**EL PASO COUNTY PLANNING AND
 COMMUNITY DEVELOPMENT
 DEPARTMENT**

CONSTRUCTION DRAWINGS CHECKLIST

OUTLOOK POWERS & GRINNELL

CIVIL CONSTRUCTION PLANS

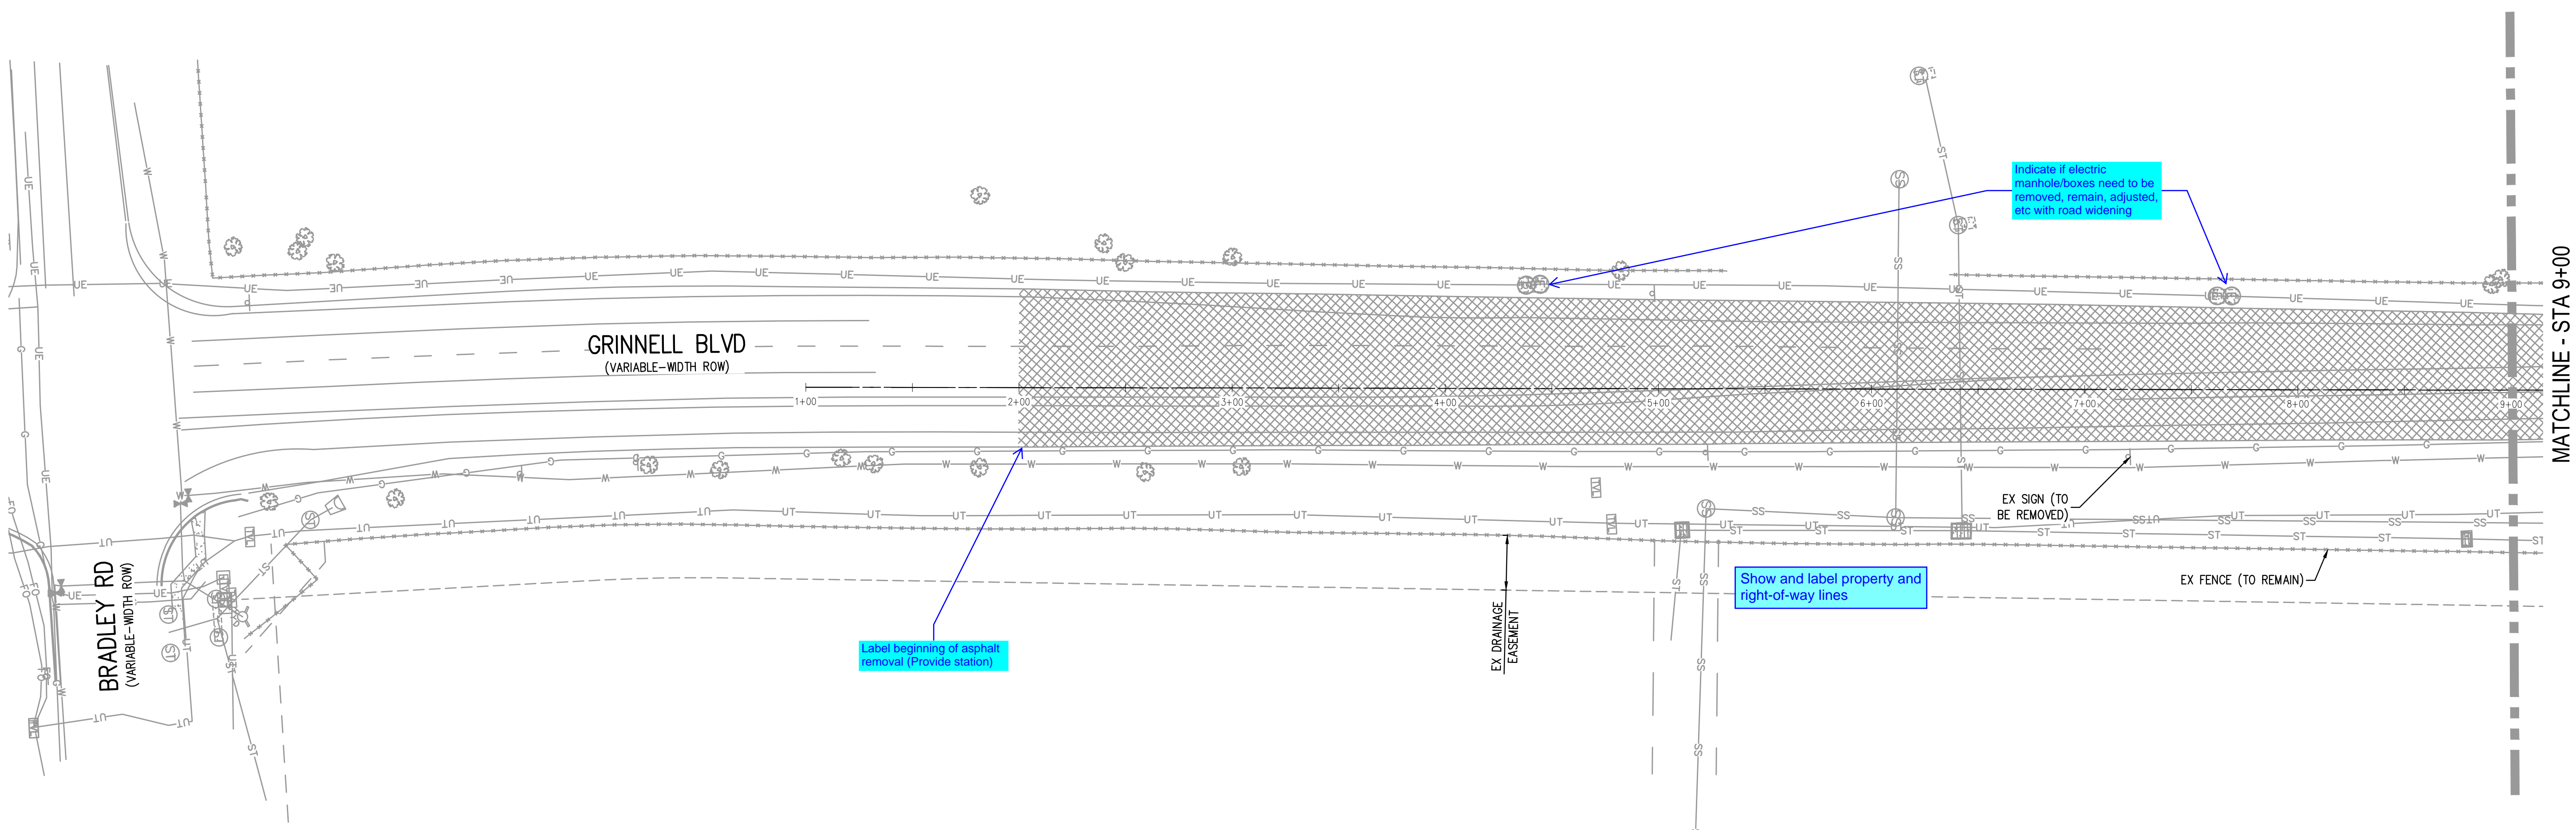
Indicate if electric manhole/boxes need to be removed, remain, adjusted, etc with road widening

Label beginning of asphalt removal (Provide station)

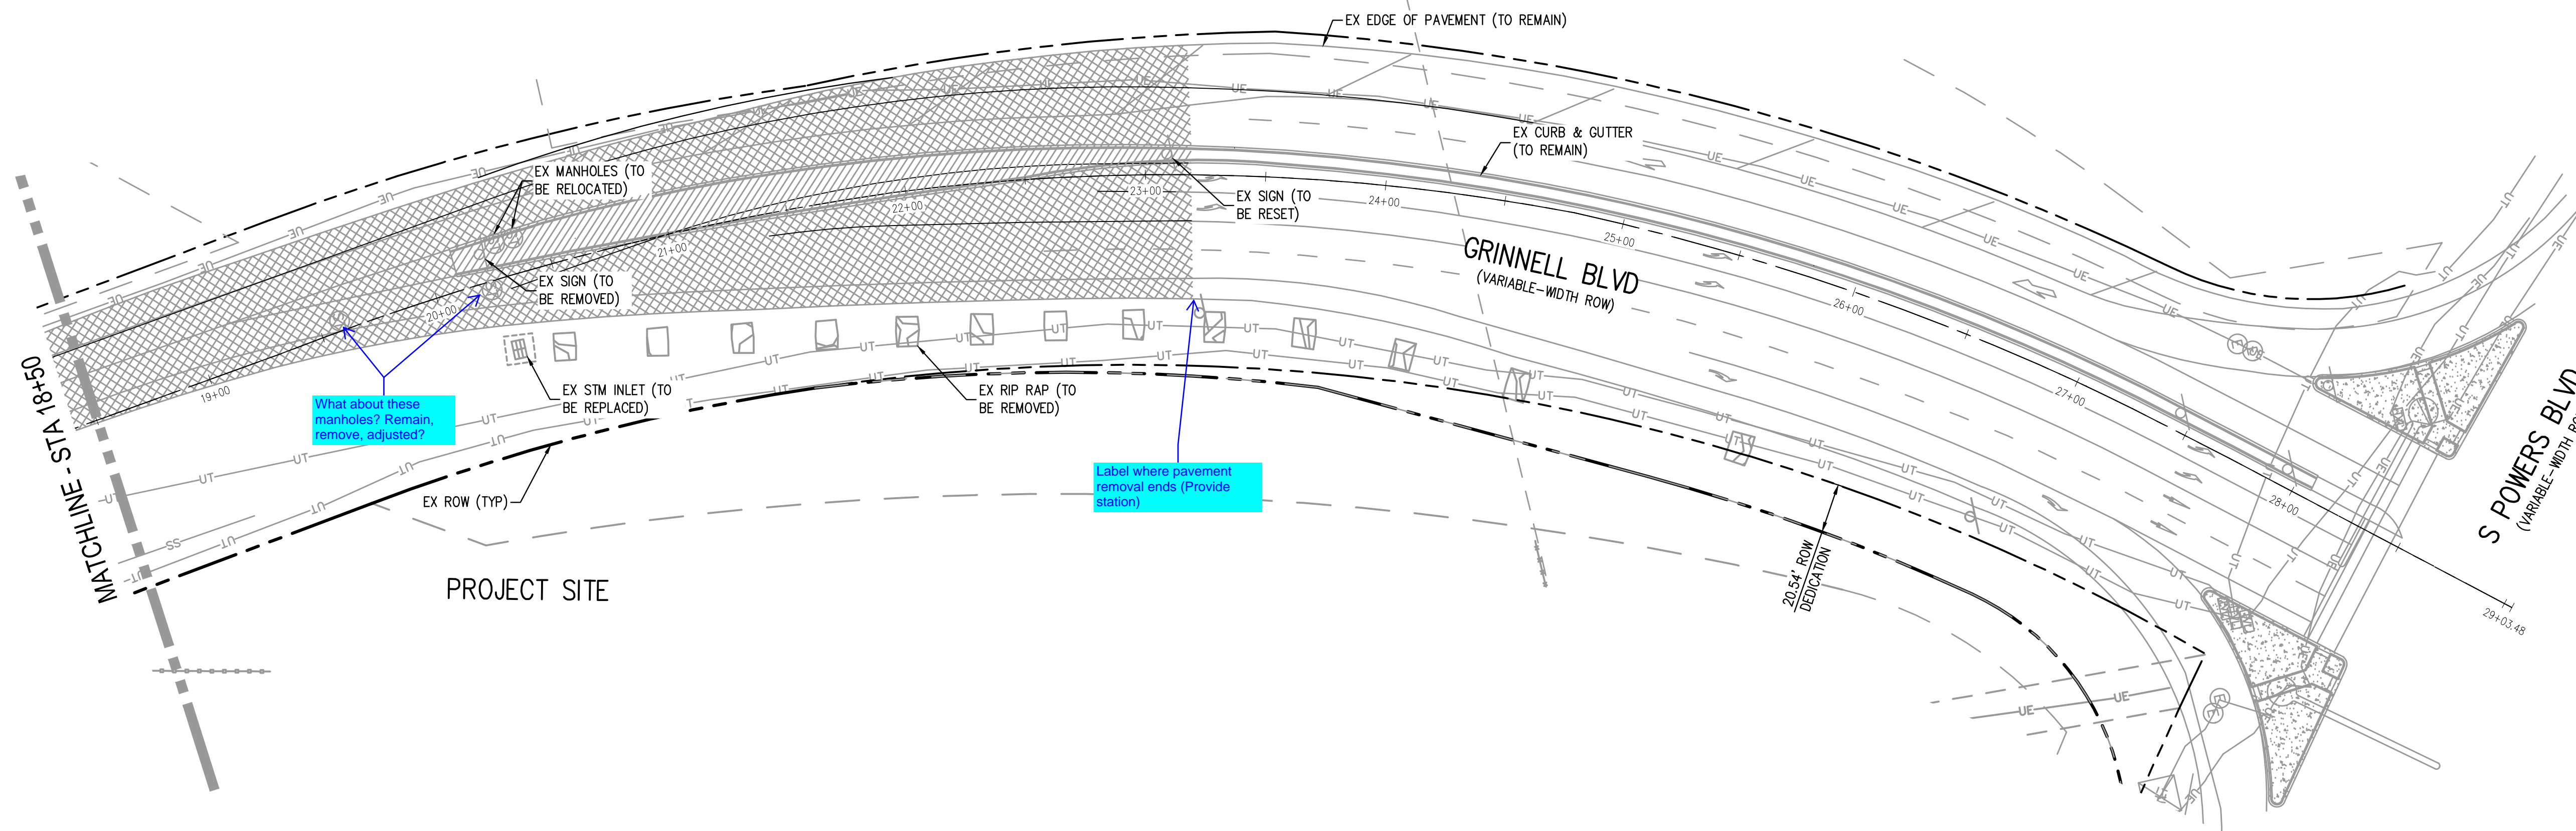
What about these manholes? Remain, remove, adjust?

Label where pavement removal ends (Provide station)

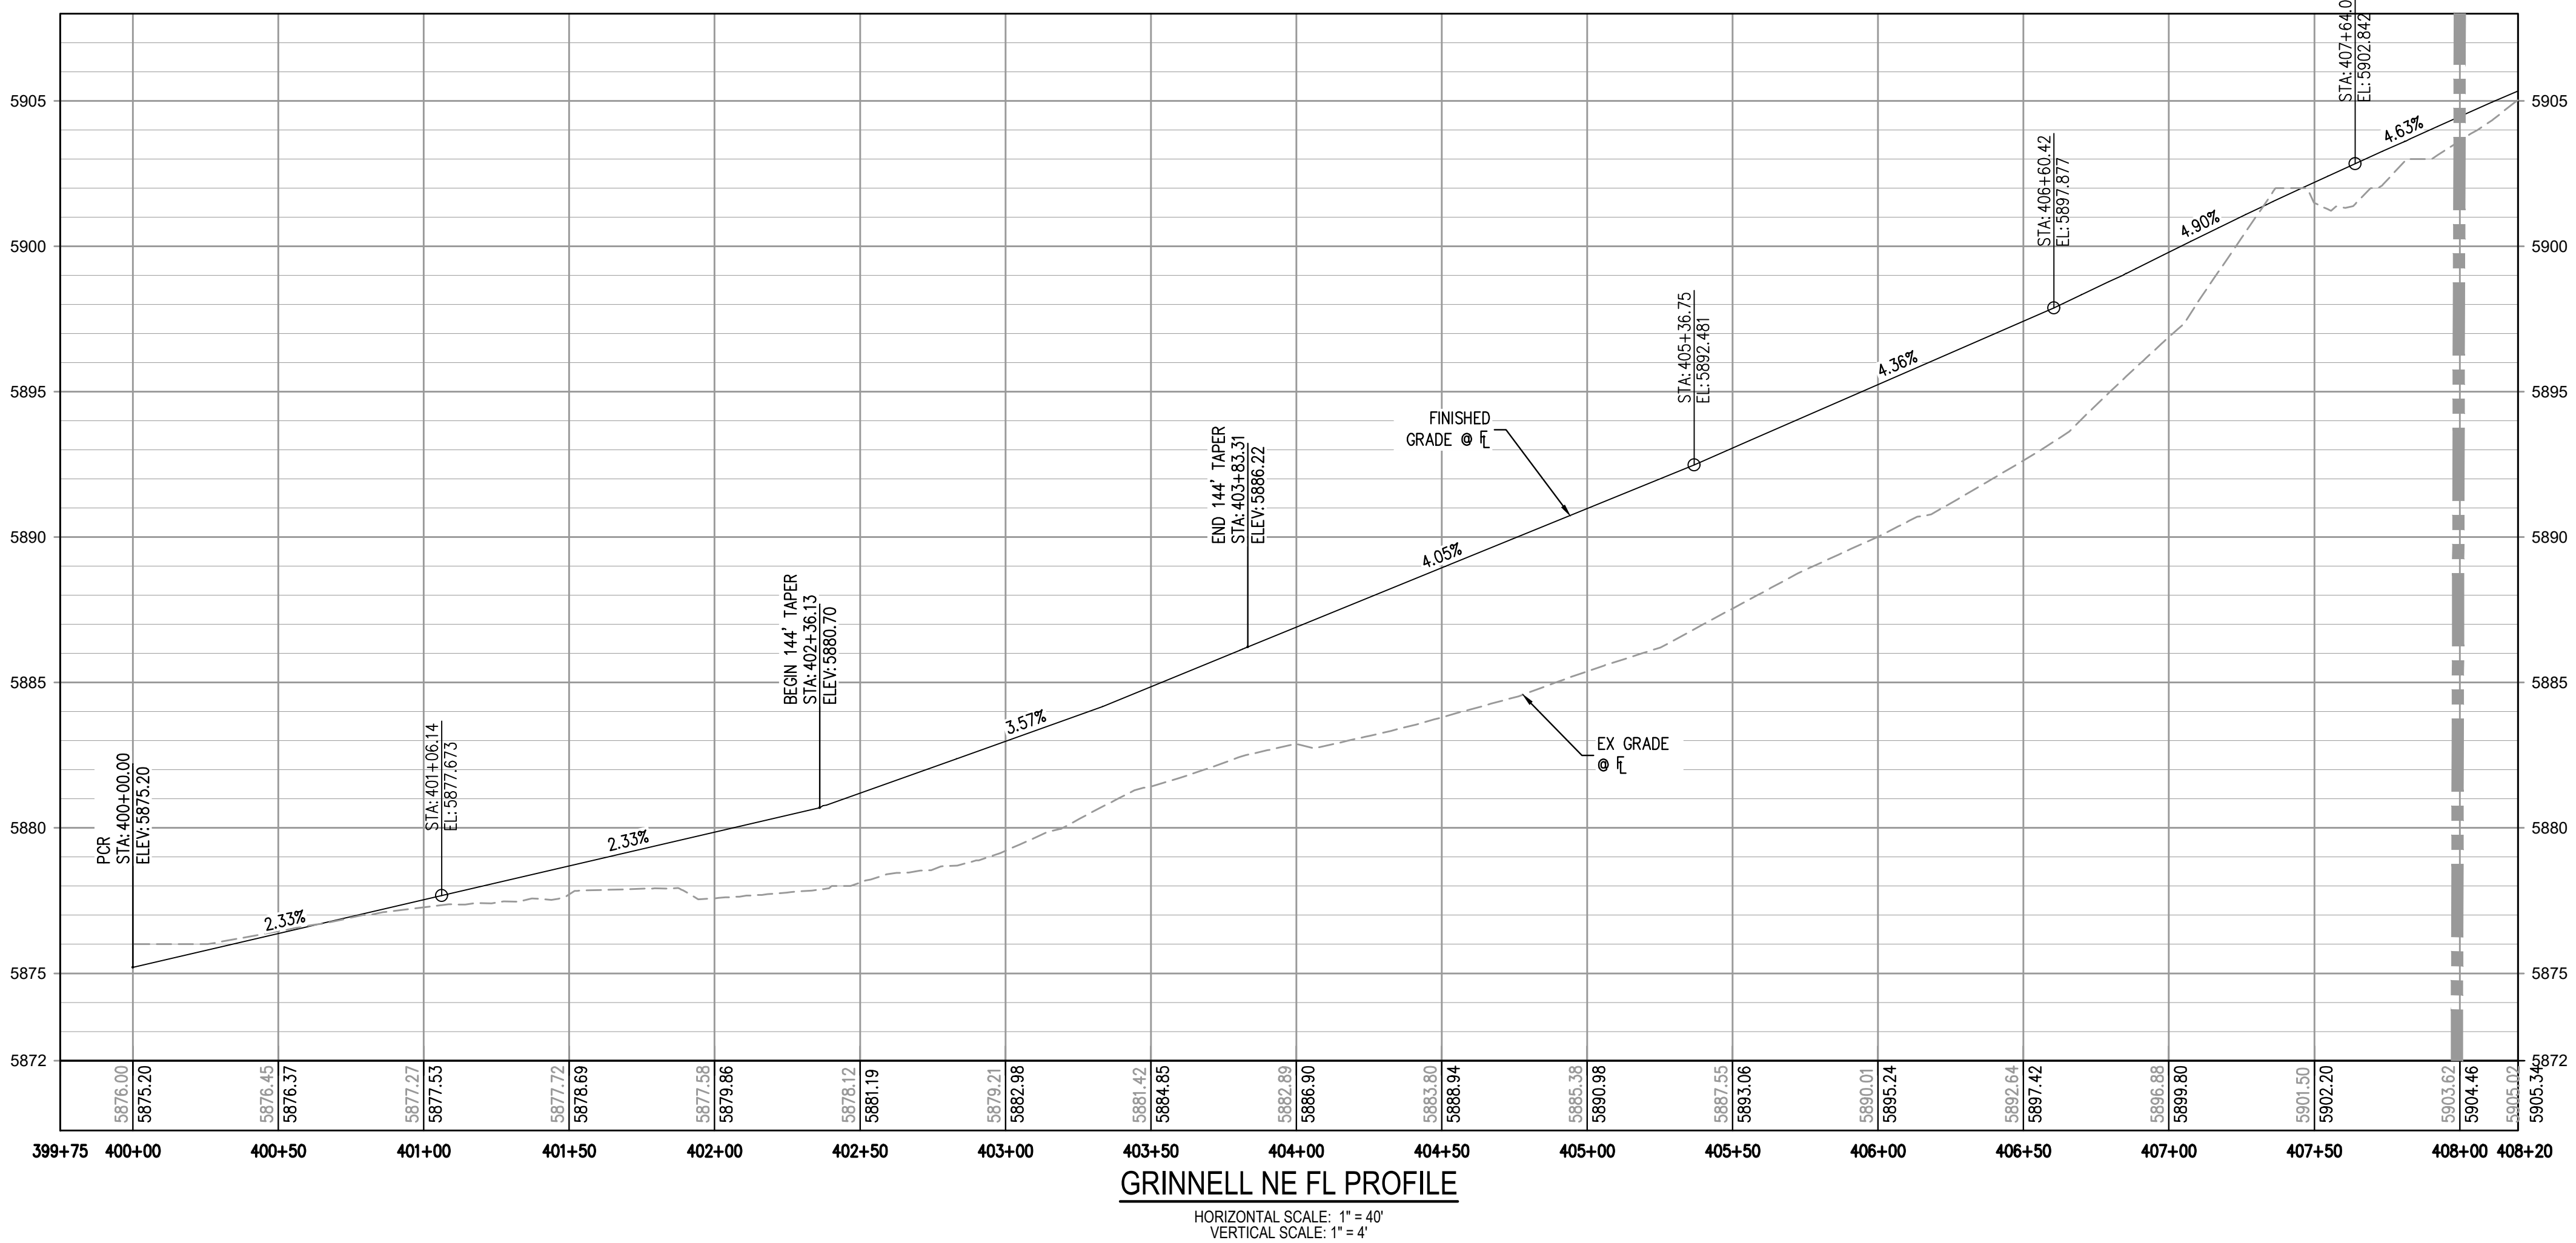
provide a detailed spot grading with slope tags for all proposed pedestrian ramps. Example from other projects

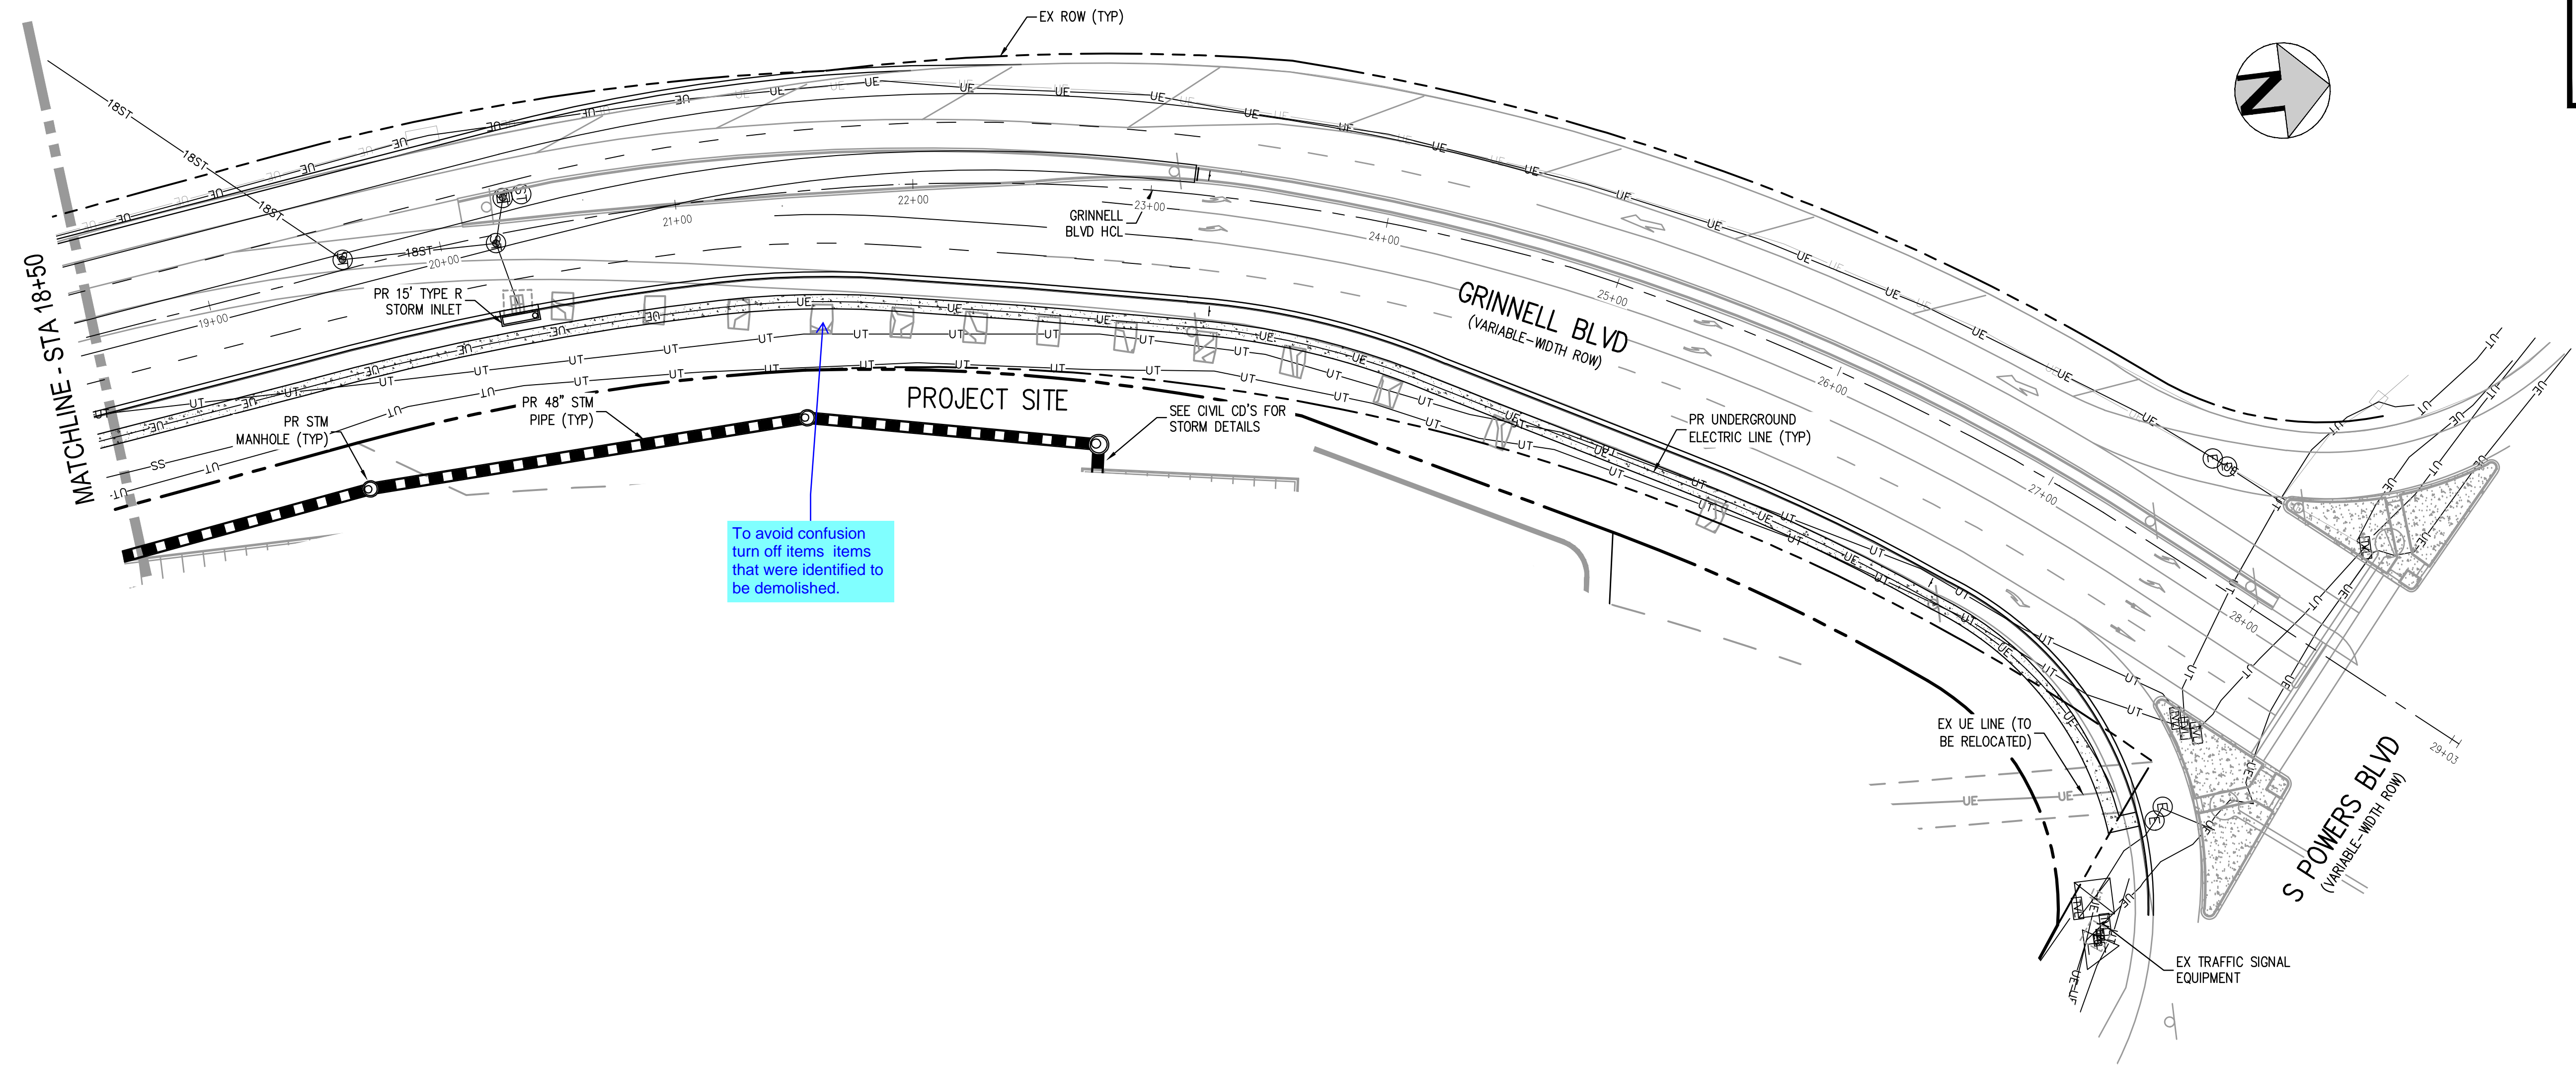
To avoid confusion
turn off items items
that were identified to
be demolished.
